**RE: Town of Kittery, Planning Board Services
35 Badgers Island West Residential Conversion Drainage Review #3
Tax Map 1, Lot 32
CMA #591.156**

**Re: Preliminary Site Plan Review Application; Conversion to Residential
Tax Map 1, Lot 32, 35 Badgers Island West
Response to CMA Comments**

SCHEMATIC MANHOLE

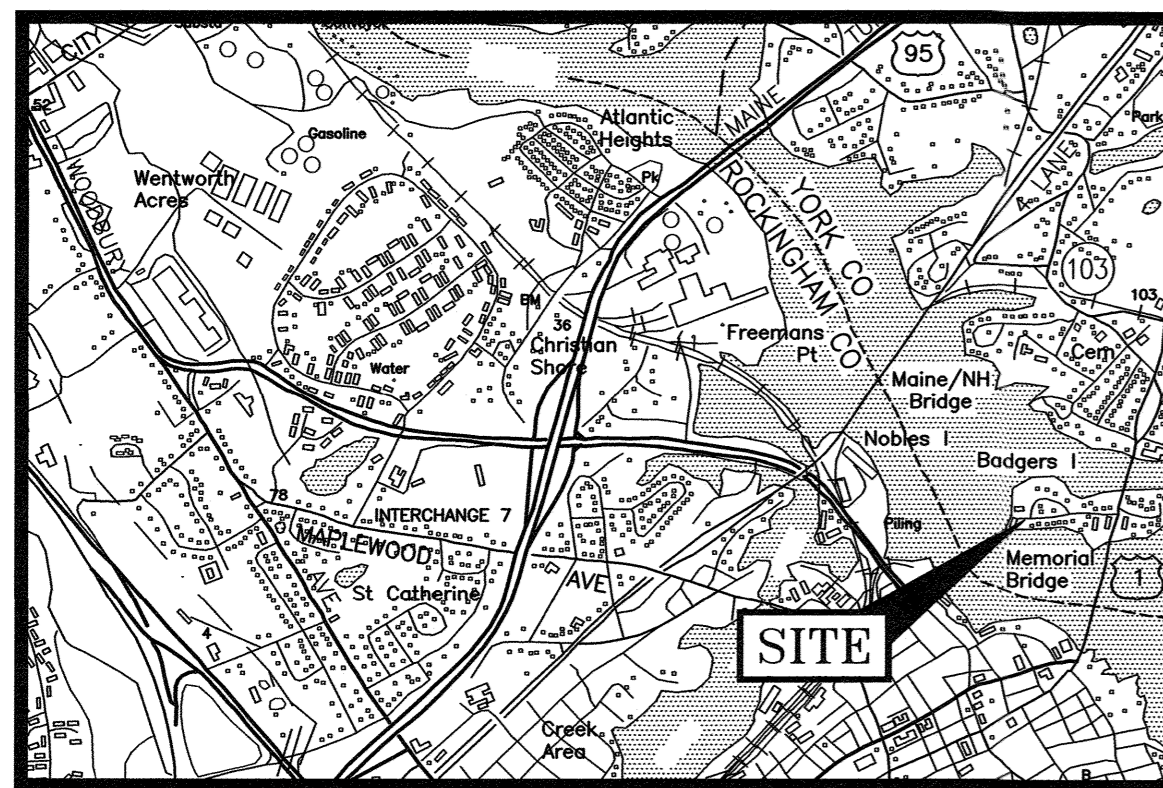
1. The proposed sewer service contains a change in pipe direction at a three-foot drop in elevation and is serviced by a cleanout. This is not a conventional design and has the

potential to easily become clogged. The design should include a manhole with a drop inlet. **Please see attached a PVC manhole to address the concern. Once approved we will update the plans.**

C1

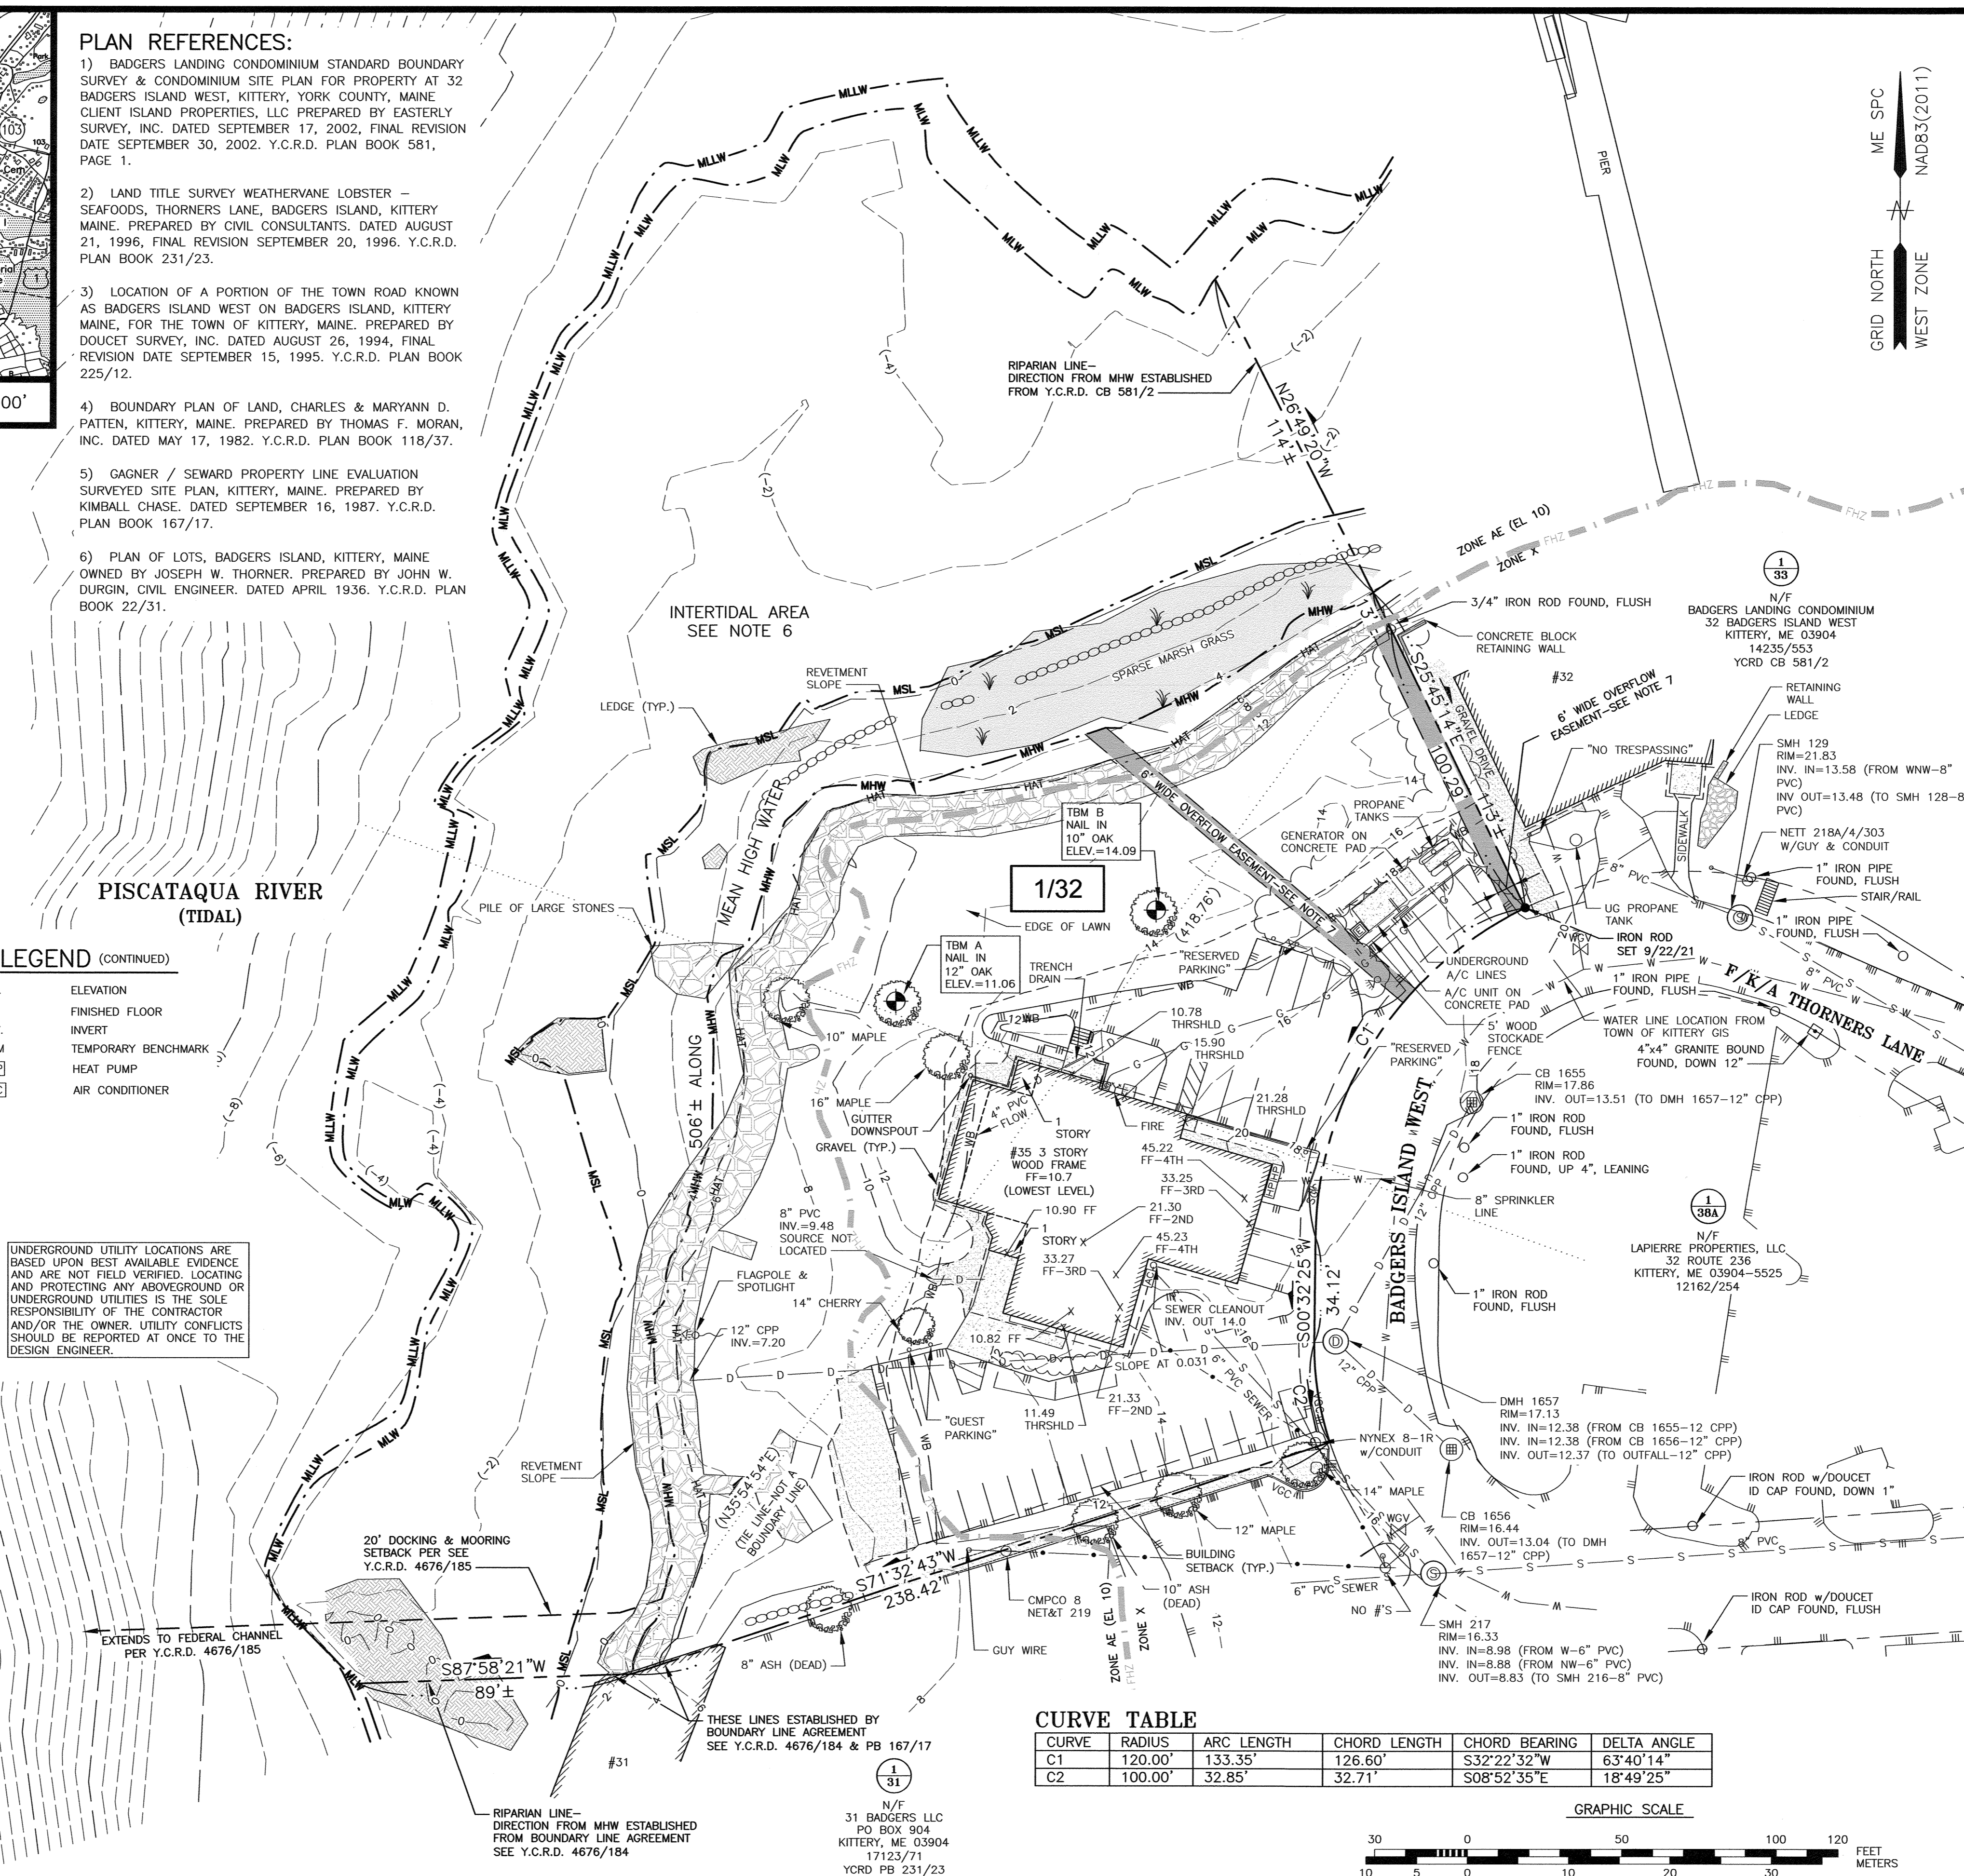
Sheet C1 – Existing Conditions Plan

1. Label the size and material of the water services and water main.
2. Is the 6' "ceptic" easement required to be maintained? It is not shown on any subsequent plans.

1. Label the size and material of the water services and water main. **There is an 8-inch sprinkler line servicing the building. Currently the domestic is tapped from that line inside the building. This is not an uncommon arrangement and has operated and has been approved. A new domestic line will be run, if required. The water services will be fully coordinated with the Water District.**
2. Is the 6’ “ceptic” easement required to be maintained? It is not shown on any subsequent plans. **No, that is an old deed reference, no pipe was installed in that location, and no septic pipe will ever be installed in that location.**

L-1
 Sheet 1 of 1

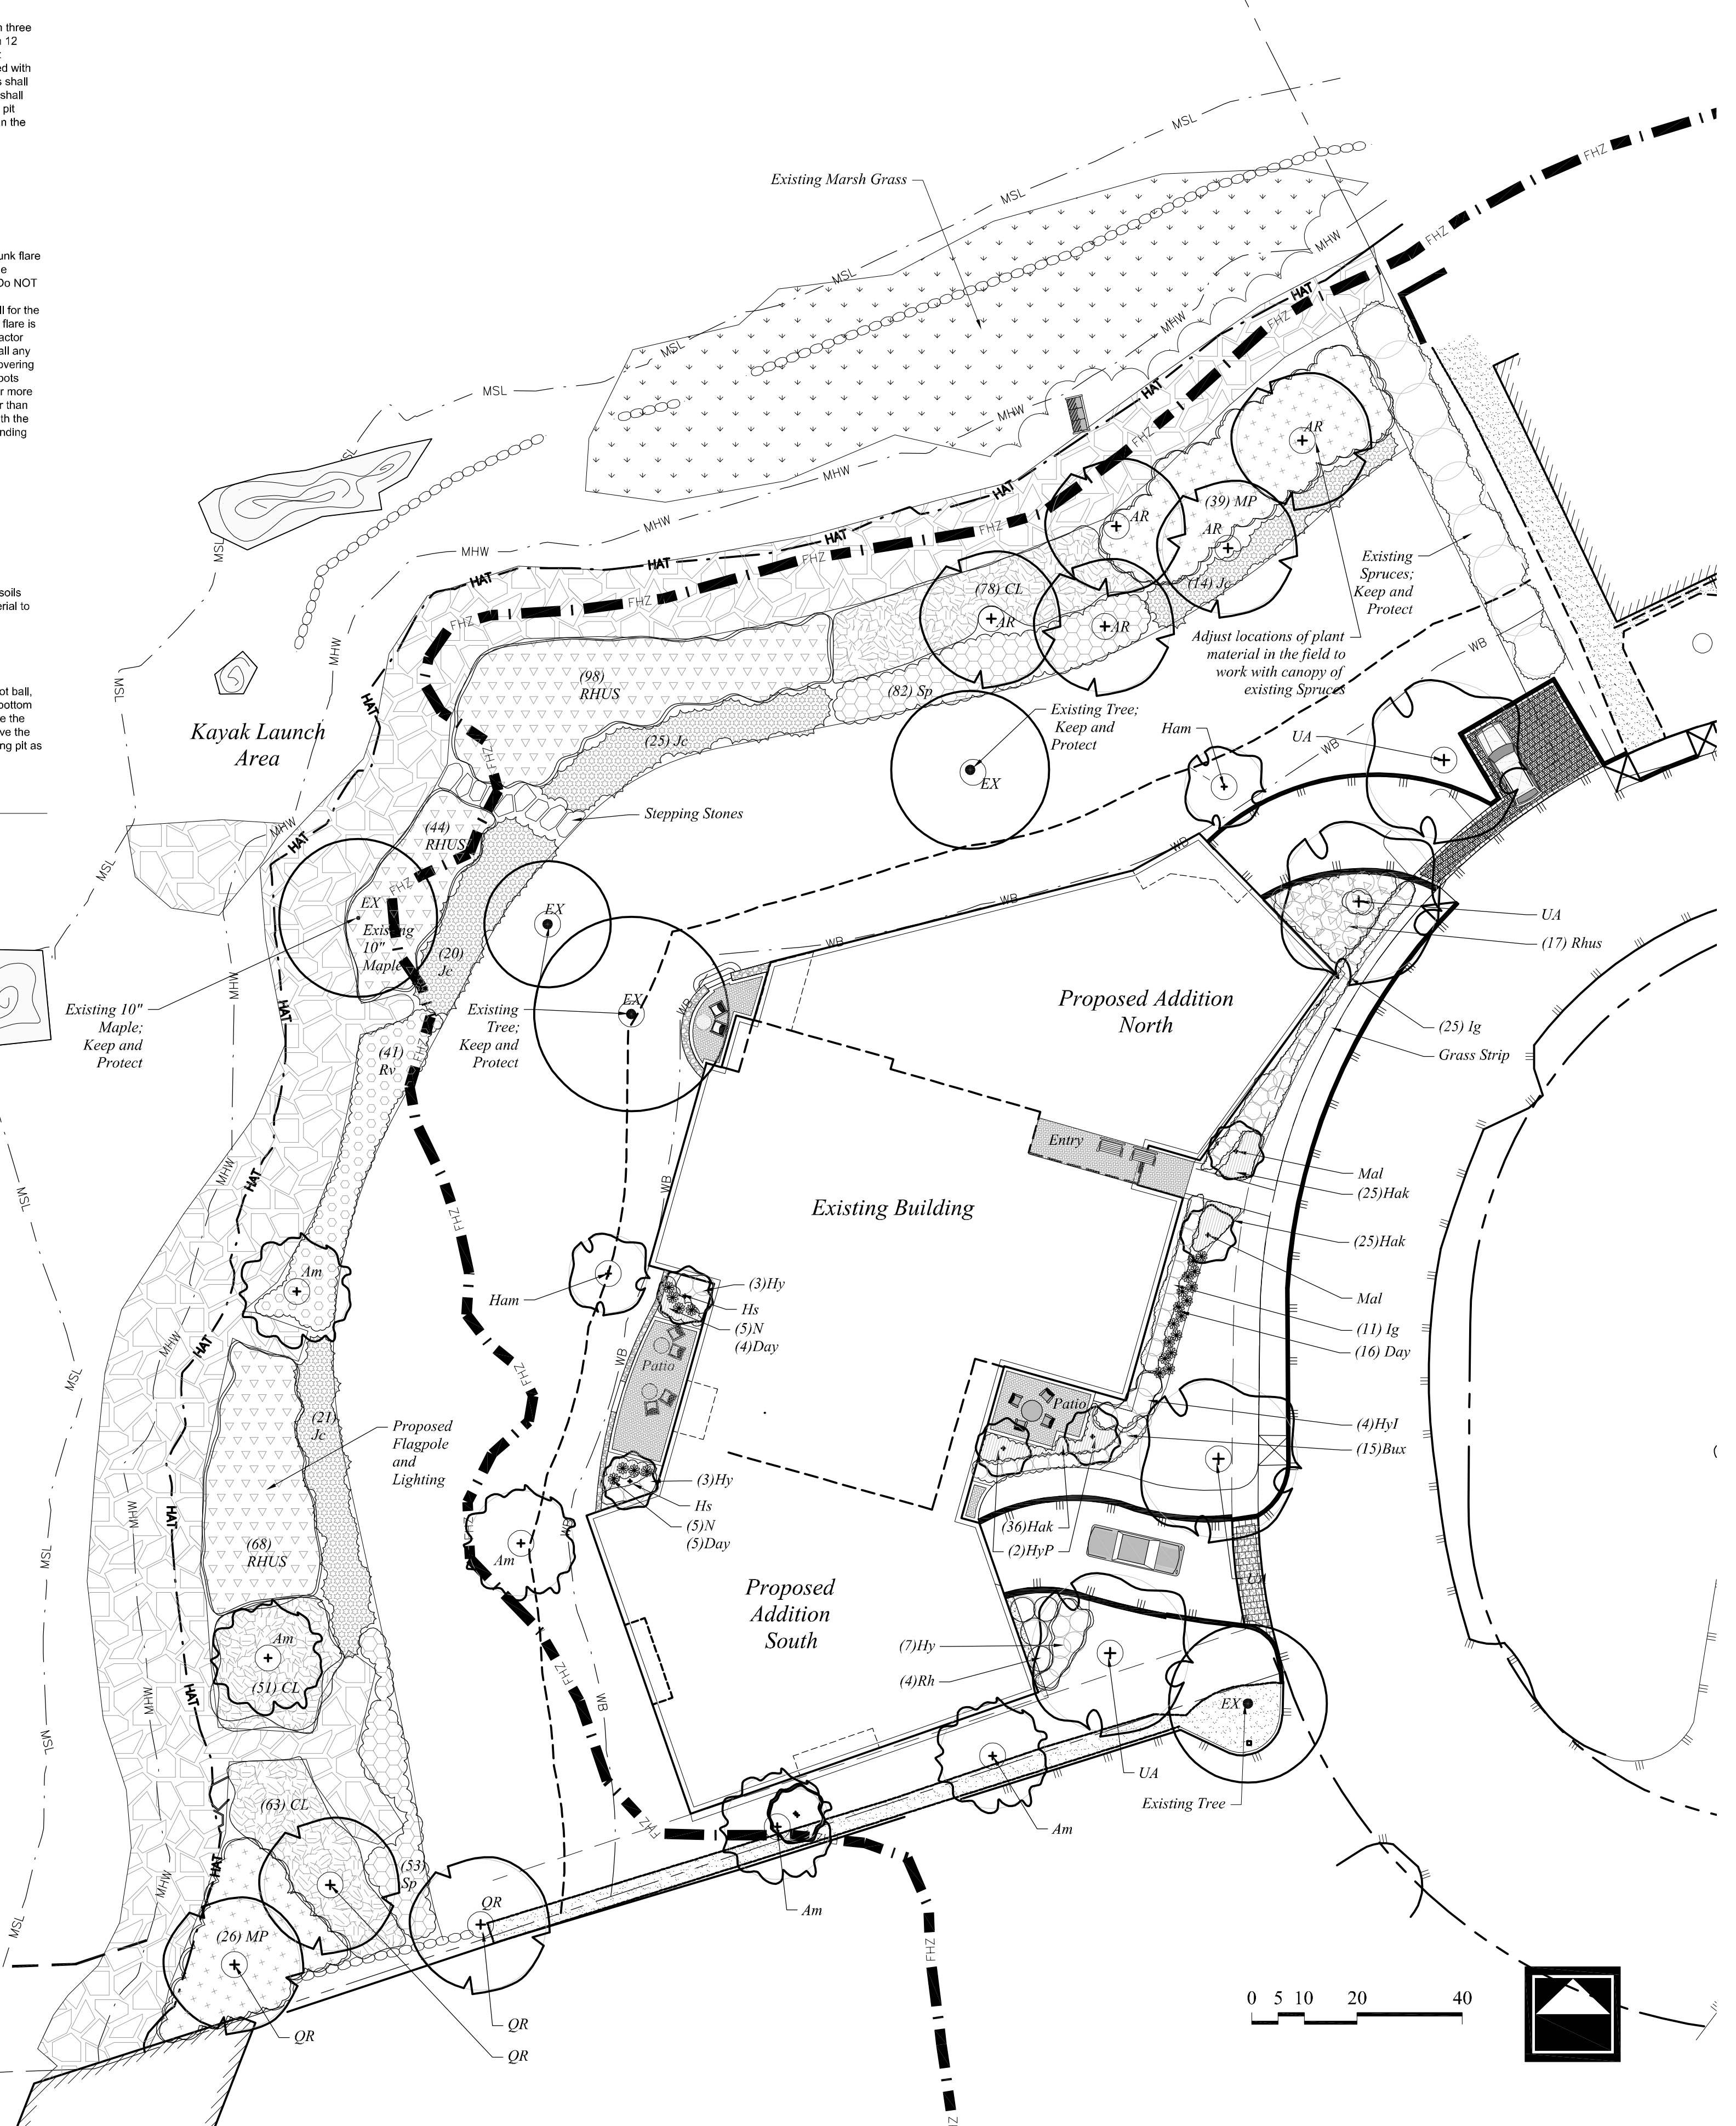
1. The leader “Tree line to be cut back to landscape plan limits” should be removed or clarified. There is no cutting back of the tree line shown on the landscape plan. **Both the C5 Plan and the L1 Landscape Plan have been clarified.**
